FINAL PLAT
ELLSON COURT ADDITION
AN ADDITION TO WICHITA, SEDGWICK COUNTY, KANSAS

RE: SUB 2000-56 -- One-Step Final Plat of ELLSON COURT ADDITION

RE: SUB 2000-56 -- One Step Final Plat of ELLSON COURT ADDITION

CASE NUMBER: SUB 2000-56 -- ELLSON COURT ADDITION

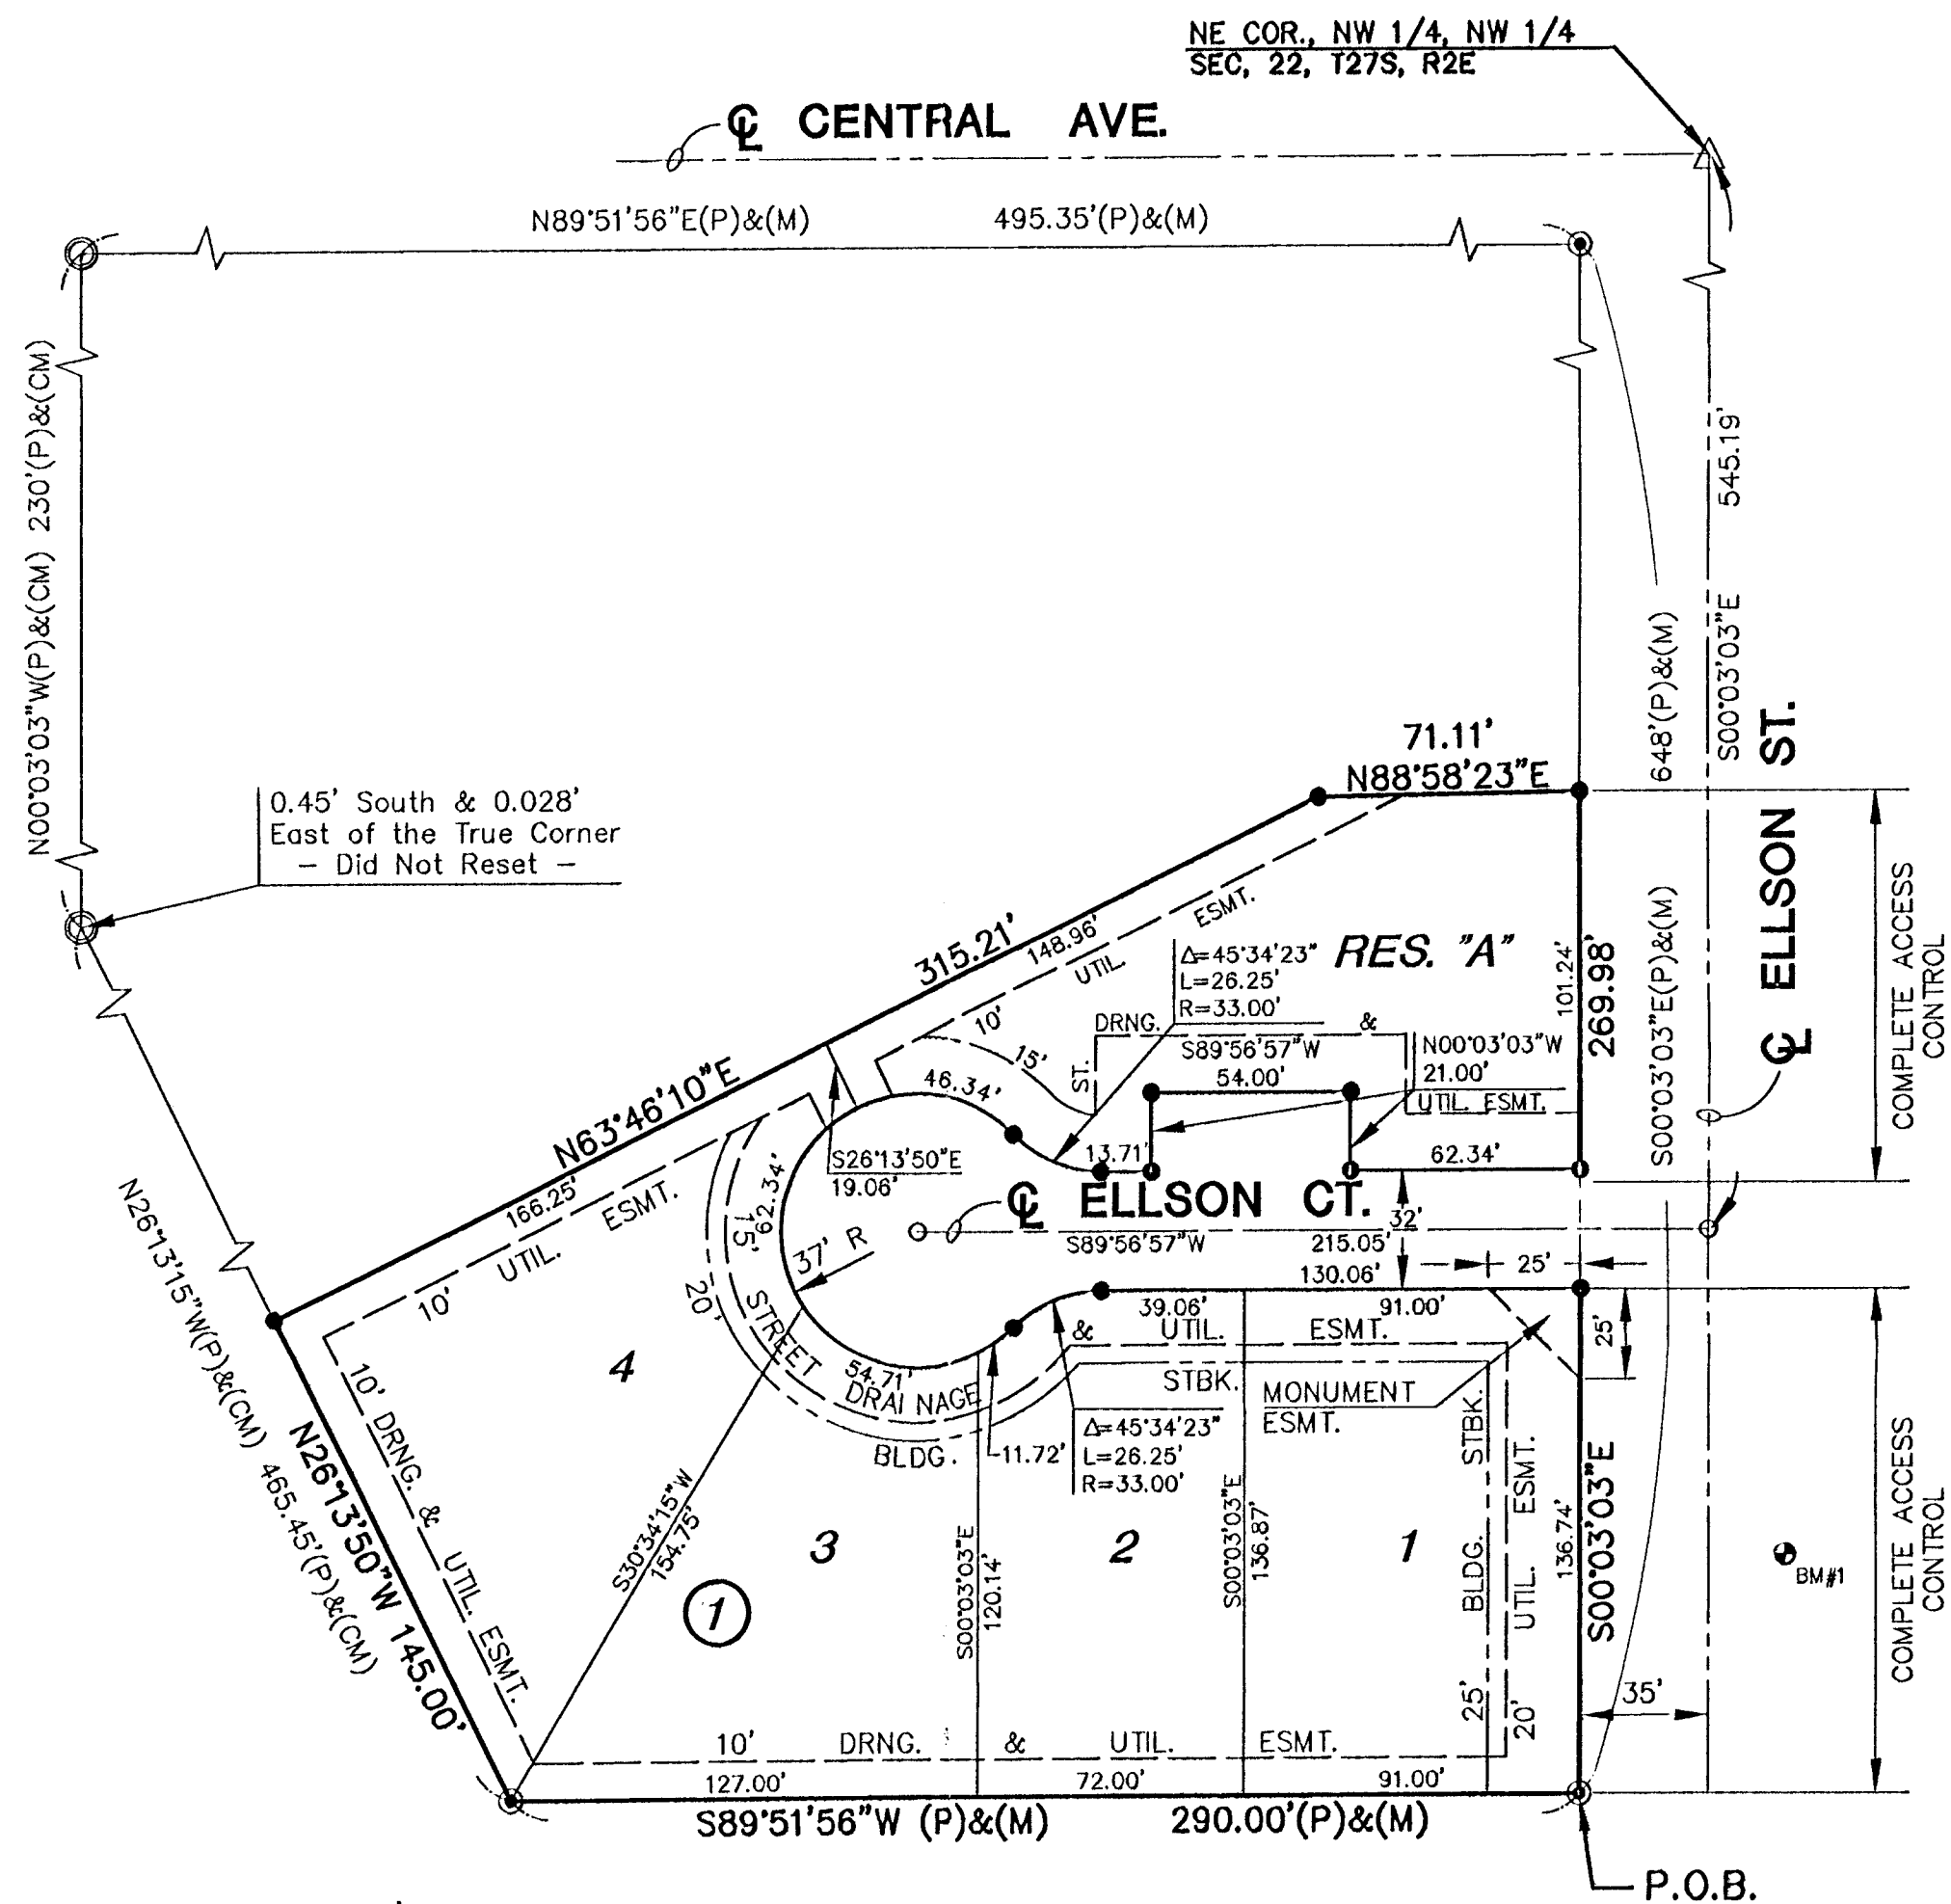
- A. This plat will be subject to approval of the associated zone change and any related conditions of such a zone change.
- B. The lots will be served by the Four Mile Creek sanitary sewer system. On the final plat tracing, appropriate wording shall be added to the Mayor's signature block indicating the City's agreement to allow a County sewer district to be formed within the City. County Engineering advises that the Sedgwick County Sewer District Impact Fee for development of each dwelling unit in this Addition is \$12,050.07. This amount is not amortized by special assessment and is due and payable in full when initial permits are pulled. The Applicant has requested the removal of Lots 1-4 from the Four Mile Creek Sewer District in order to connect with City sewer.

- E. City Engineering needs to comment on the status of the applicant's drainage plan. The drainage plan is approved.
- F. A minimum pad elevation as shown on New Life Christian Church Addition of 1366.4 MSL (179 City Datum) needs to be added.

- G. A benchmark needs to be added.

- I. The dimension on the east line of Lot 5, Block 1, needs to be changed from 230.94' to 155.72'.
- J. Provisions shall be made for ownership and maintenance of the proposed reserves. The applicant shall either form a lot owners' association prior to recording the plat or shall submit a covenant stating when the association will be formed, when the reserves will be deeded to the association and who is to own and maintain the reserves prior to the association taking over those responsibilities. The applicant will eliminate Reserve B from the final tracing.

- M. The applicant shall guarantee the paving of the proposed interior street.
- N. Access control except one opening" should be deleted and replaced by complete access control being platted for the plat's frontage along Ellson.

- O. The building setback line should be denoted by a dashed line.
- P. Traffic Engineering shall comment on the parking easement for back-out parking that is platted within a street curve. The Subdivision Regulations require parking easements to be a minimum of 20 feet deep and have a maximum street frontage of 50 feet. The perimeter of the parking easements shall be redrawn to comply with these requirements. The applicant has agreed to revise the parking easement dimensions.

- DD. A sewer easement needs to be platted through Lot 5 and Reserve A to cover an existing sewer line.
